Cherry Intimate Ltd

Plot No 105 Dhaka Export Processing Zone, Ganakbar, Ashulia, Savar, Dhaka
Bangladesh
(23.952002N, 90.266265E)
04 May 2014

Conflicting foundation drawings are shown below

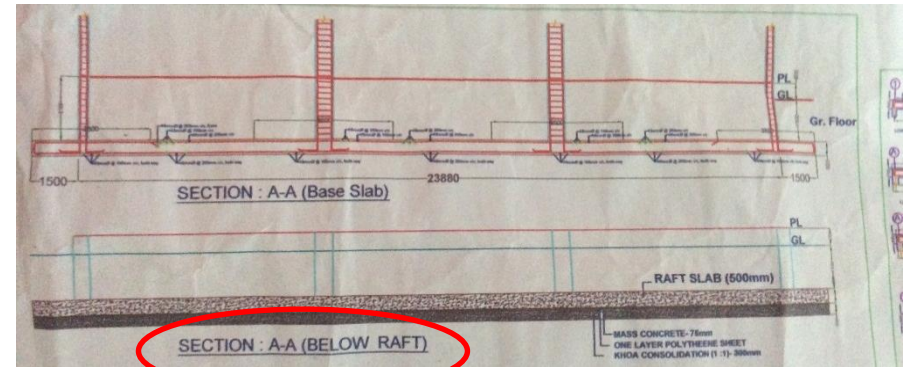
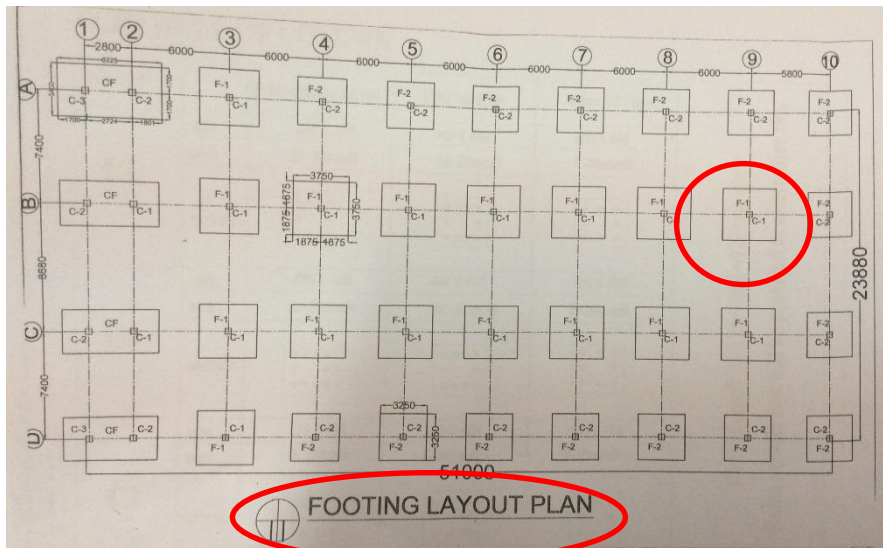
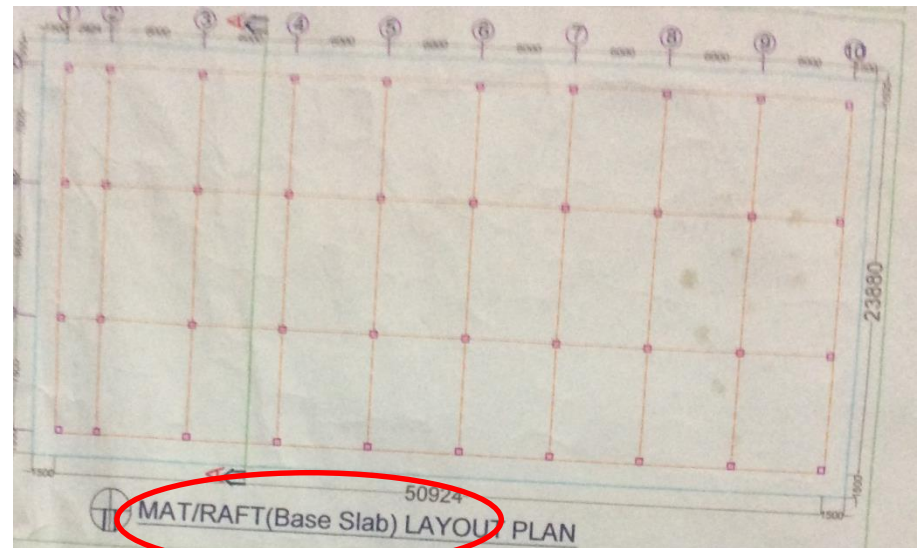
- Inconsistent column sizes were shown on different drawings. Both 500X500 and 400X400mm columns were shown. Actual column size is 430X430 mm with plaster
- There is confusion about the foundation type in the building. Different structural drawings provided, showed both raft foundation and isolated pad foundation systems.

Type of foundation was confirmed by building contractor as isolated pad foundations which may not comply with the recommendations in the Site Investigation Report.

It is not clear if any ground improvement was undertaken.

Item No.	Observation	Recommended Action Plan	Recommended Timeline
10	Differences between actual construction and information on design drawings	Engage an Engineer to prepare full “as built” engineering drawings , as part of the Detailed Engineering Assessment (refer to Priority Action 1 above).	6-weeks
11	Foundation construction may not comply with recommendations of Site Investigation Report	Building Engineer to investigate if the applied loading can be safely carried by the foundations as constructed, as part of the Detailed Engineering Assessment.	6-weeks
12	Foundation construction may not comply with recommendations of Site Investigation Report	Carry out any remedial work as directed by the Building Engineer.	6-months
13	Lightweight roof structures lack bracing and appear non-engineered	Building engineer to check the capacity and stability system of the lightweight roofs and stairs and make any necessary alterations.	6-months
